EASTONVILLE ROAD FROM LONDONDERRY DRIVE TO REX ROAD SEGMENT 1 IMPROVEMENTS STATIONING 14+19.69 - 47+66.51

OVERALL SHEET INDEX	
SEGMENT 1	SHEETS 1-42
SEGMENT 2	SHEETS 43-96

EDARP FILING NO. CDR2321

SHEET
PP.4 13

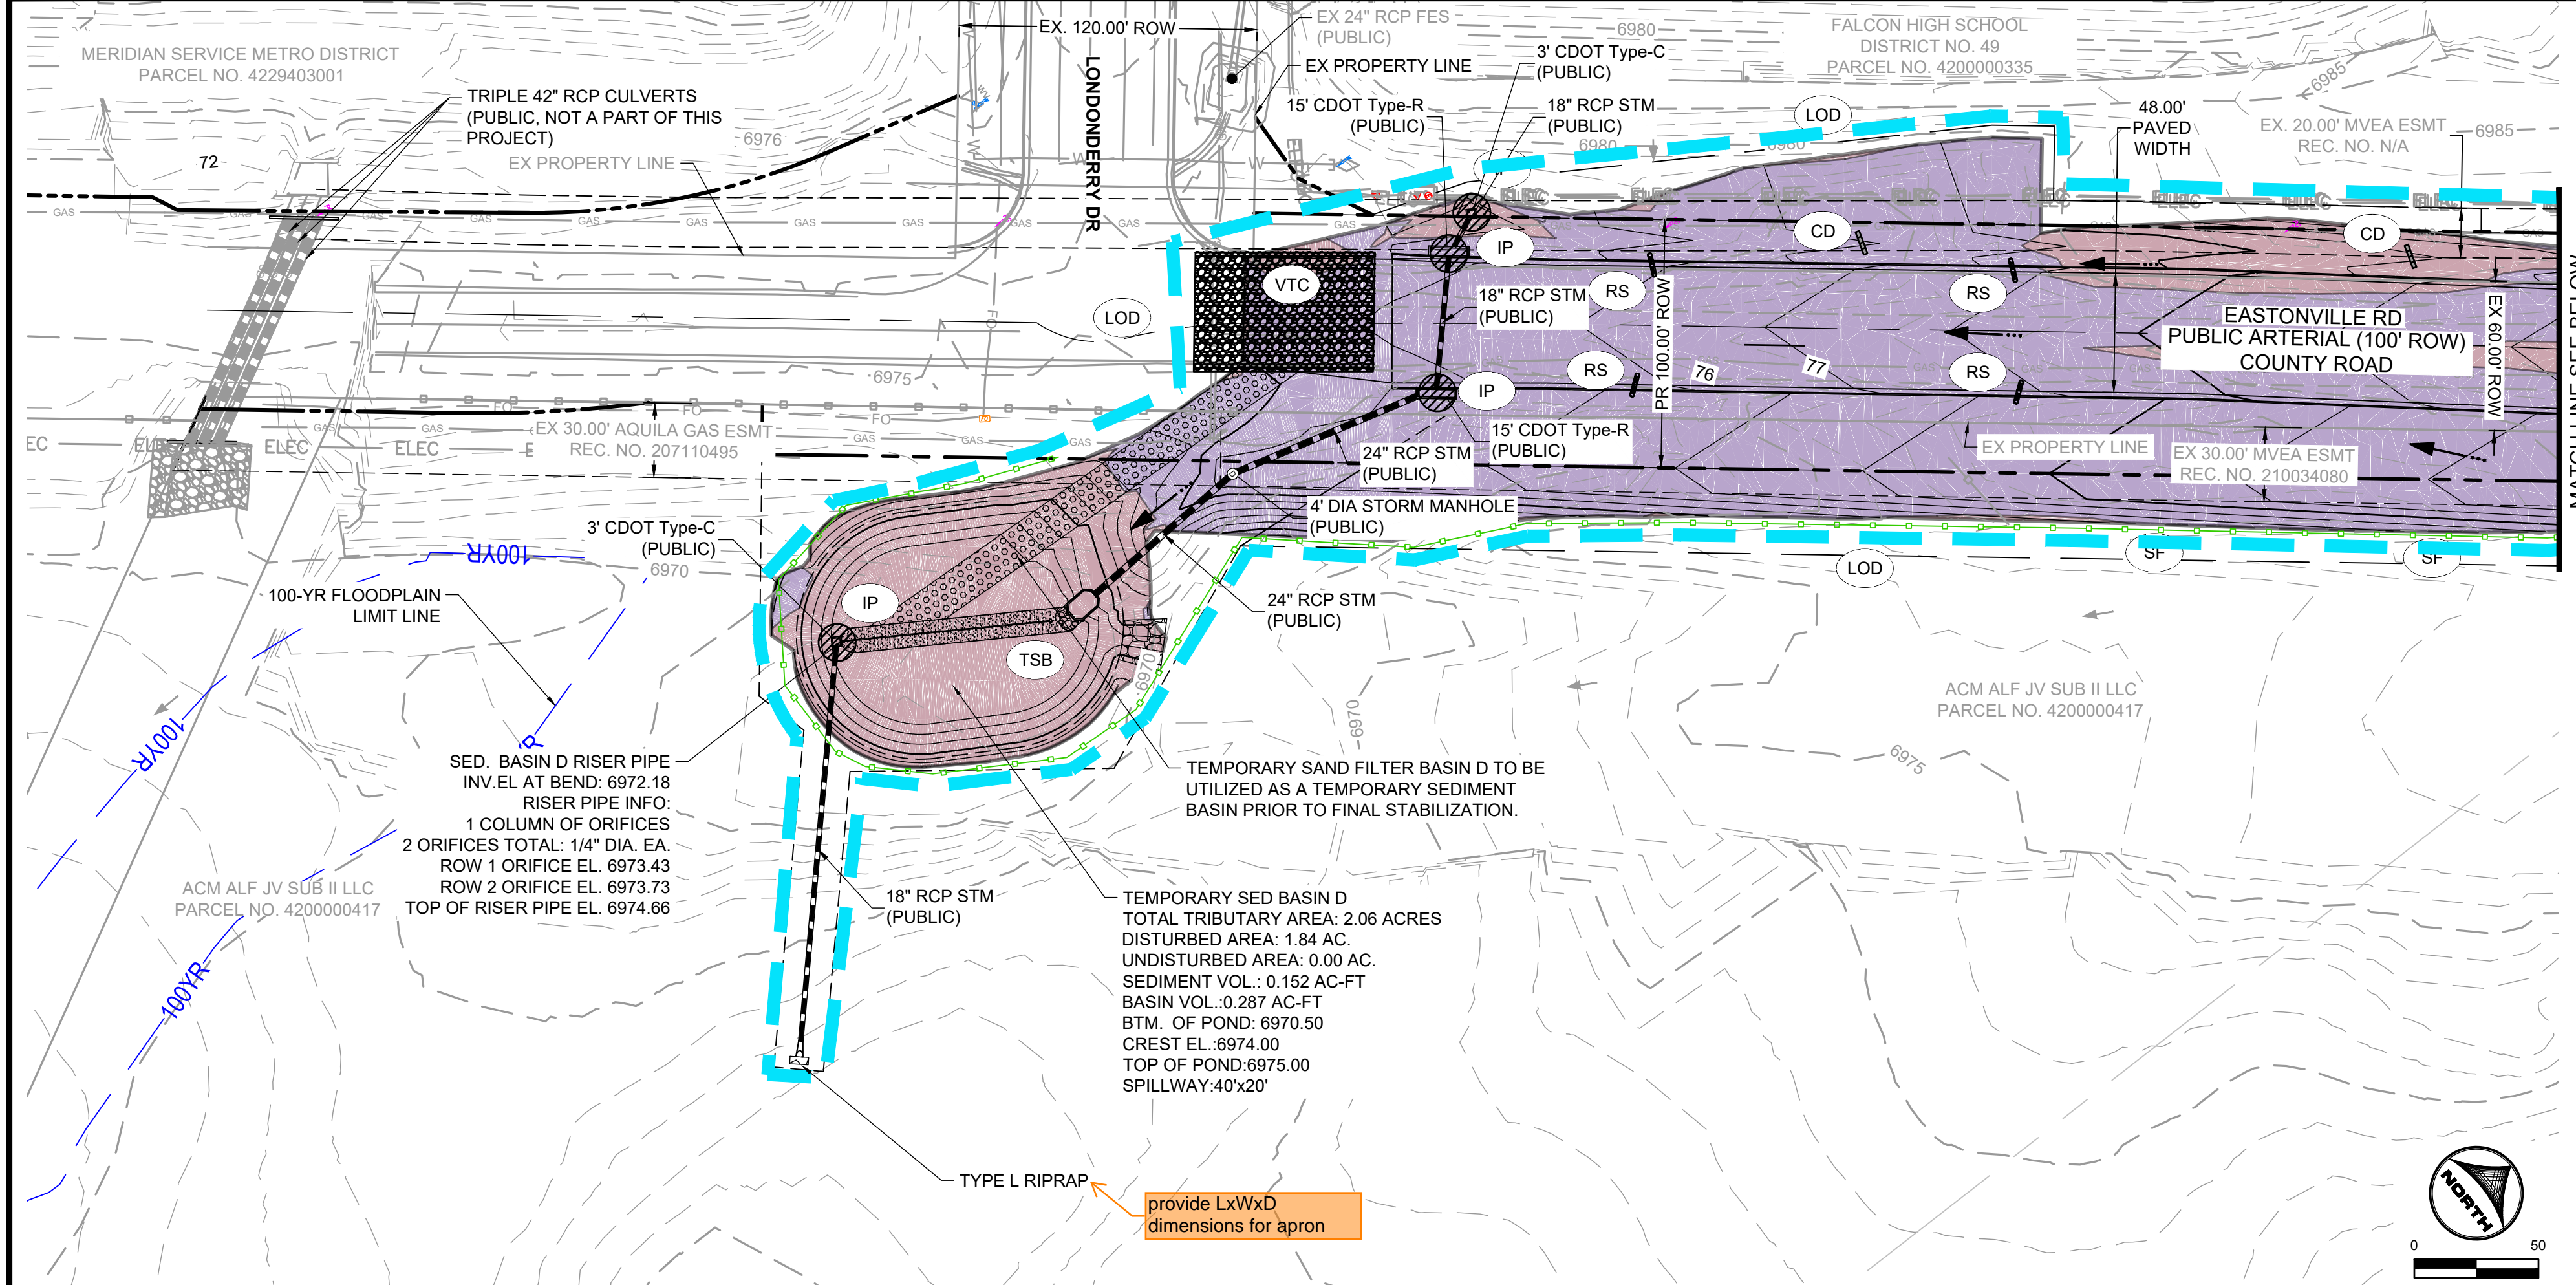
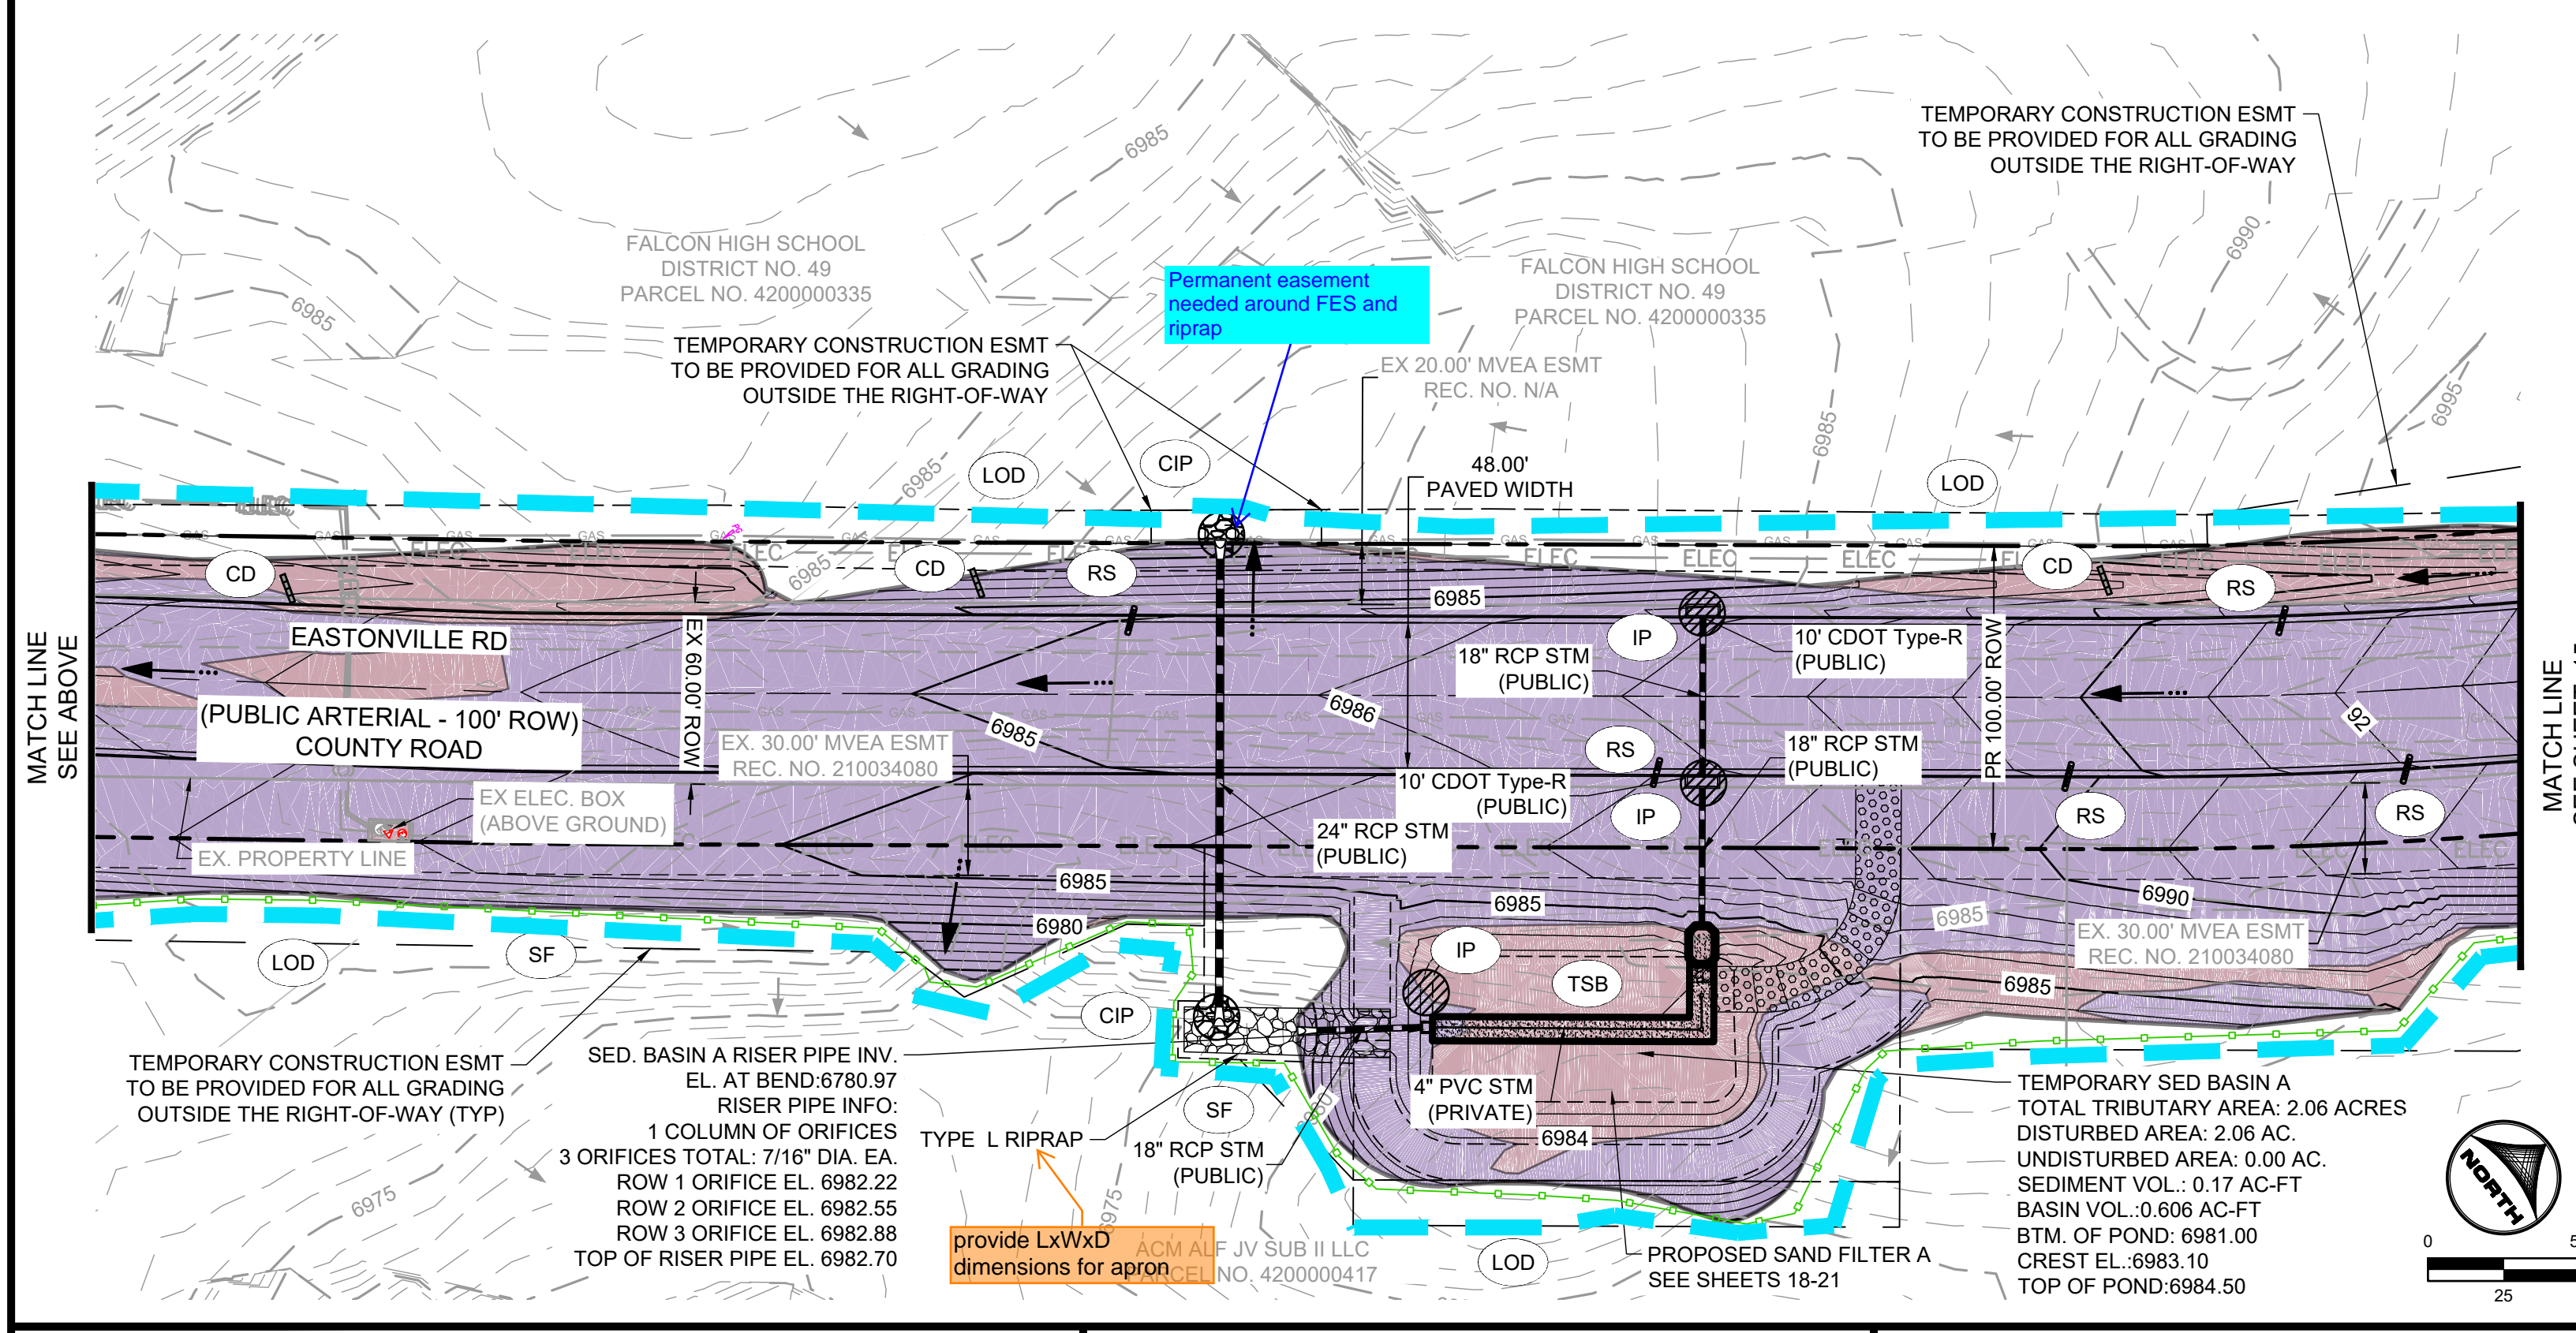
On the two sheets of GEC Plans or on a separate map, show the RPAs for Runoff Reduction that are PBMPs.

SHEET
SS.1
 16

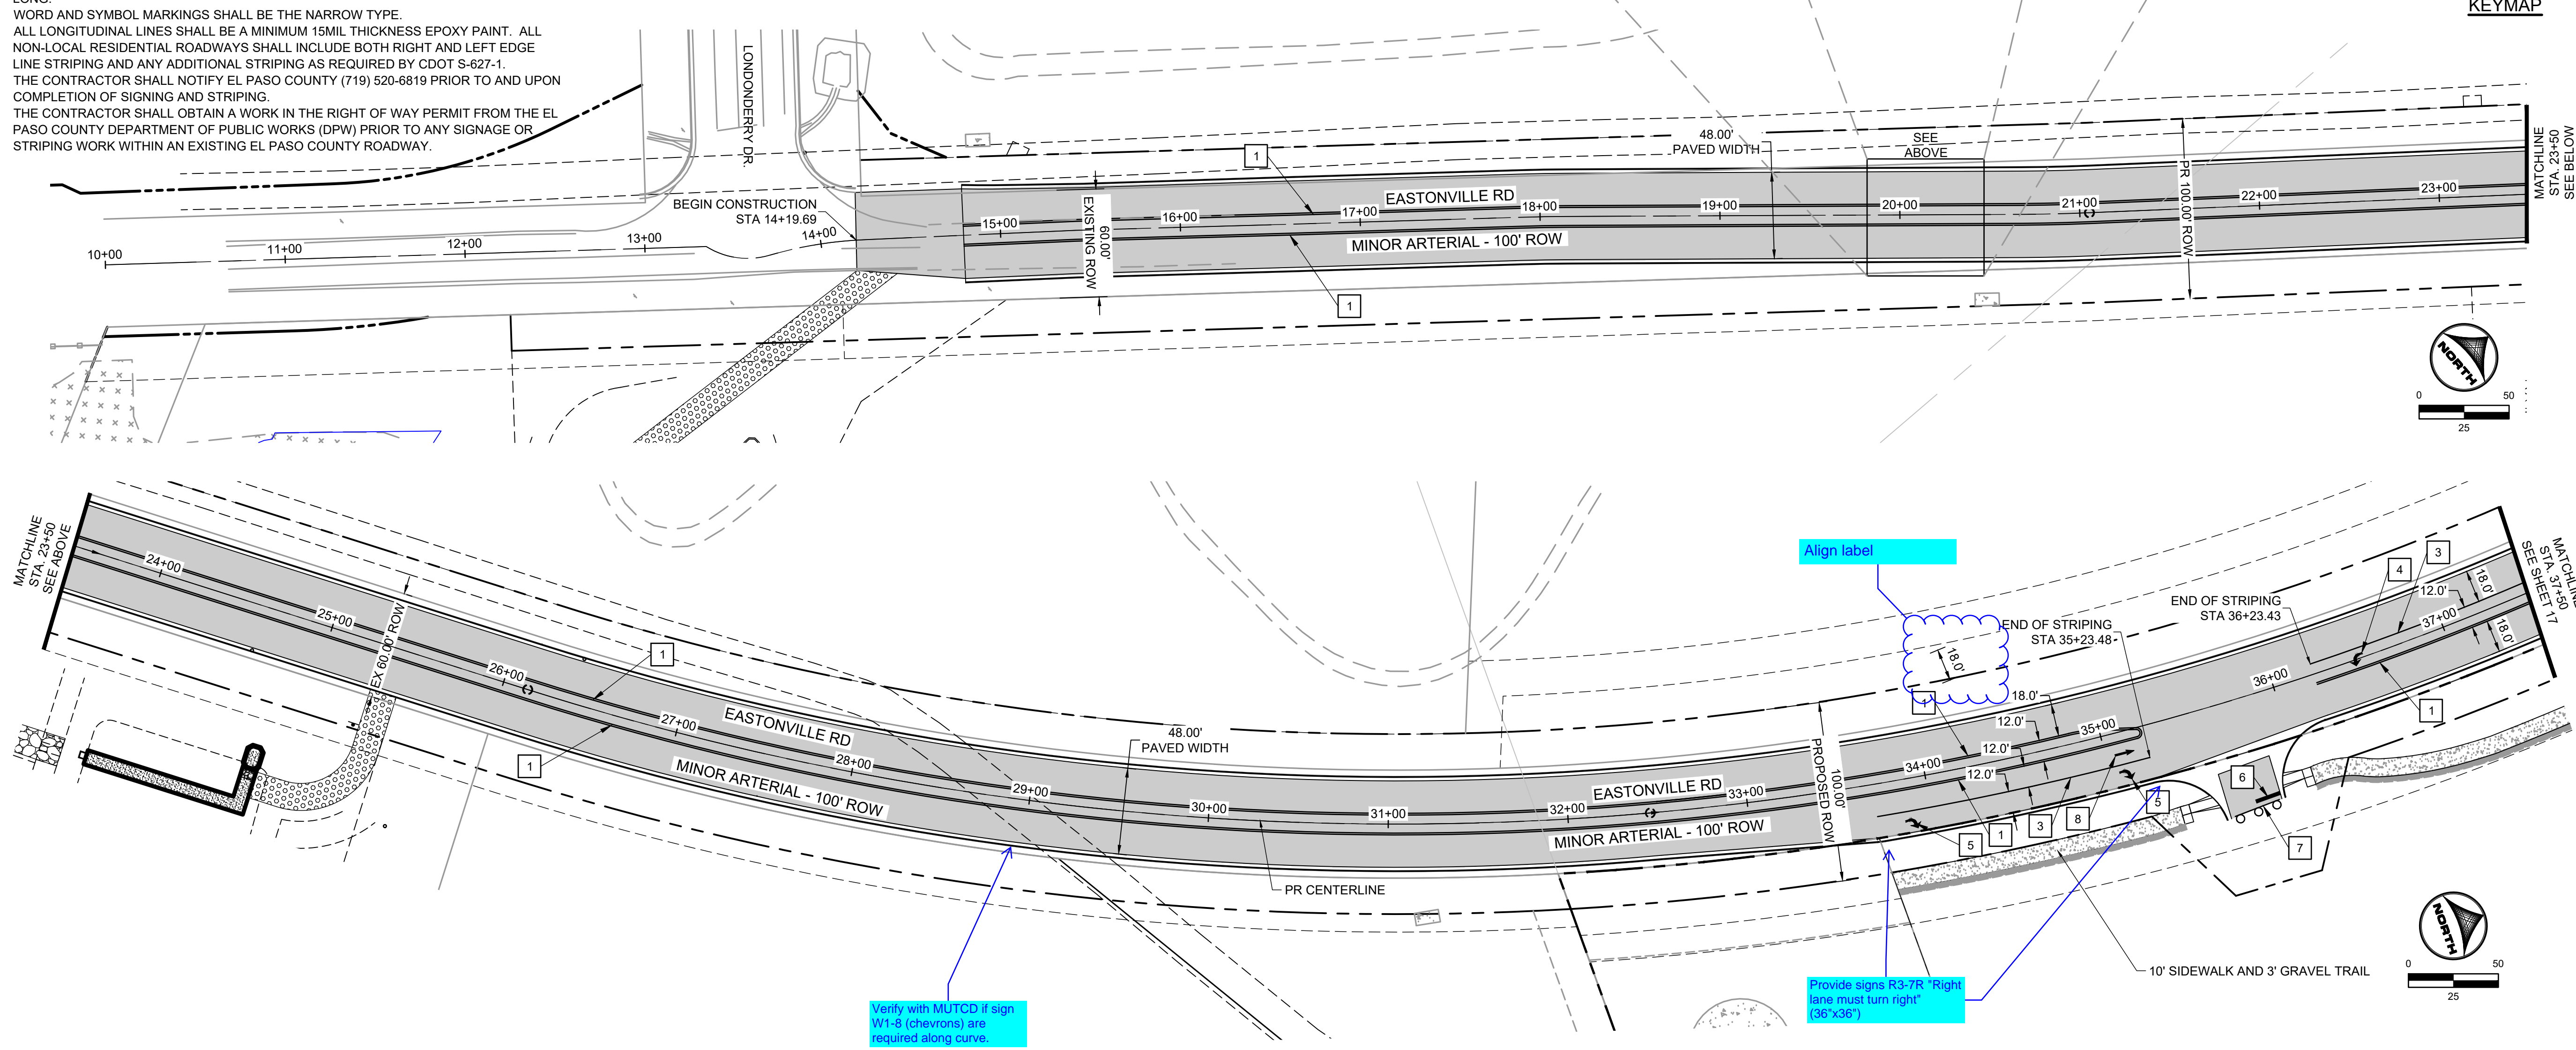
Verify with MUTCD if sign W1-8 (chevrons) are required along curve.

Provide signs R3-7R "Right lane must turn right" (36"x36")
